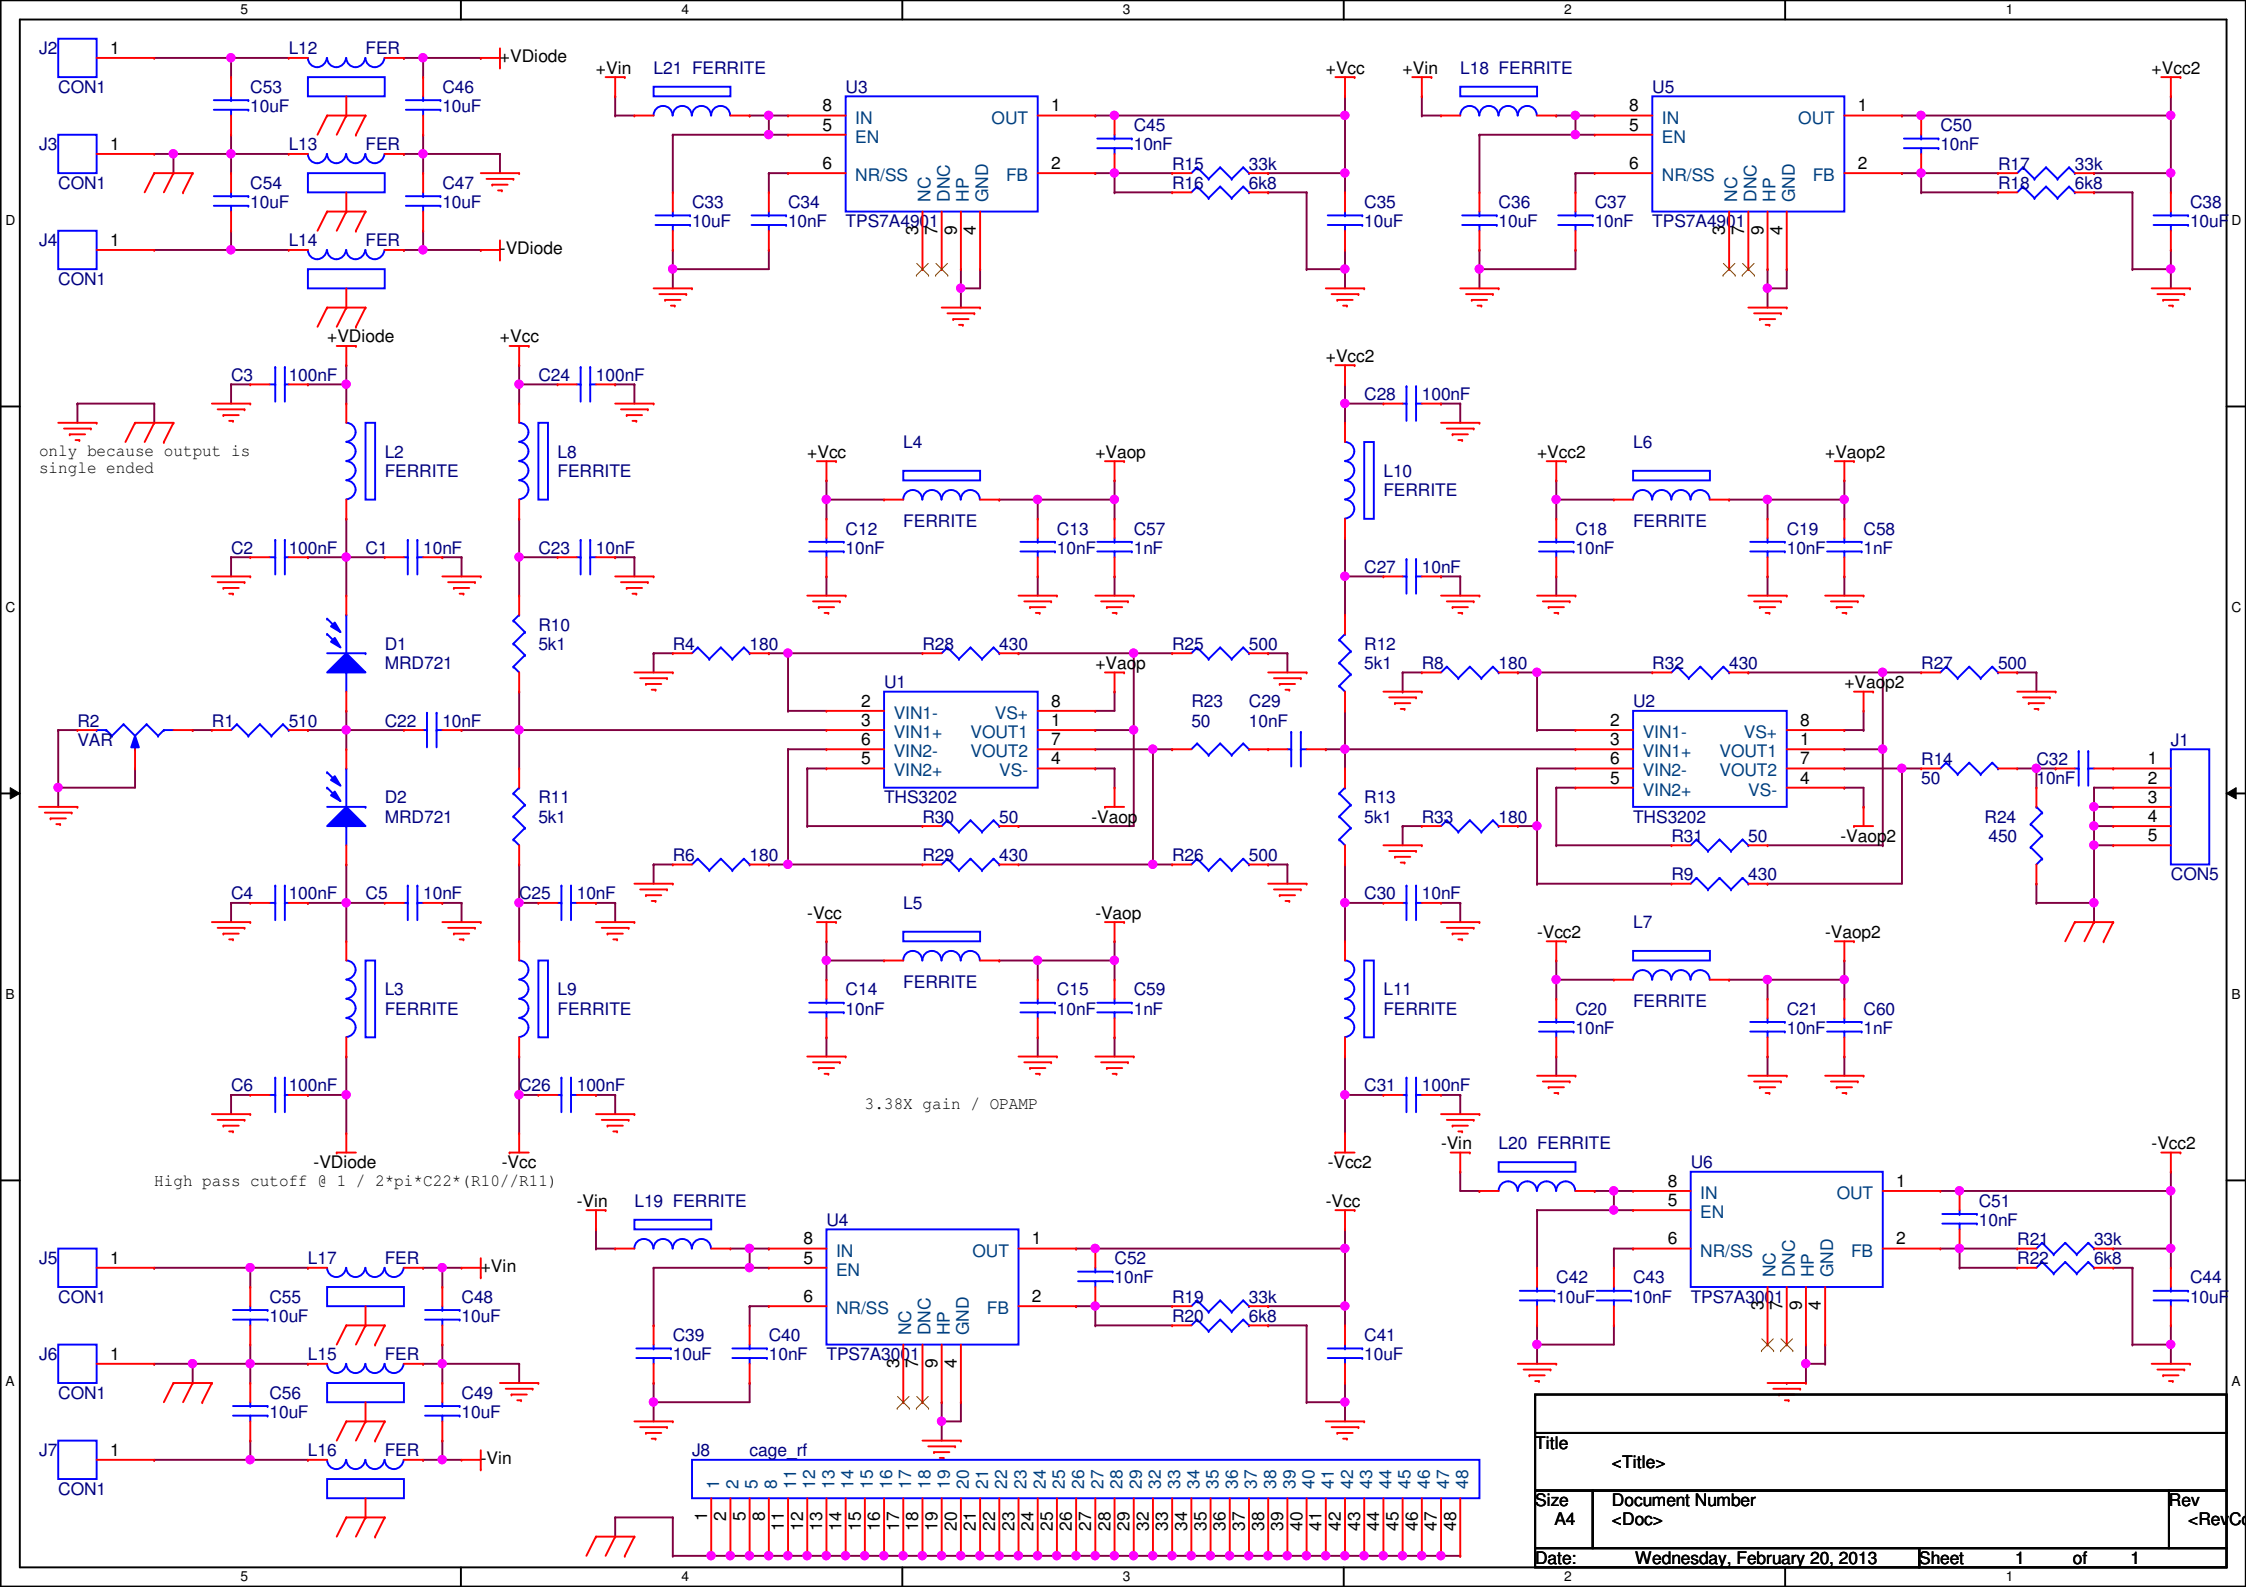
only because output is single ended

High pass cutoff @ $1 / 2 \cdot \pi \cdot C22 \cdot (R10 // R11)$

3.38X gain / OPAMP
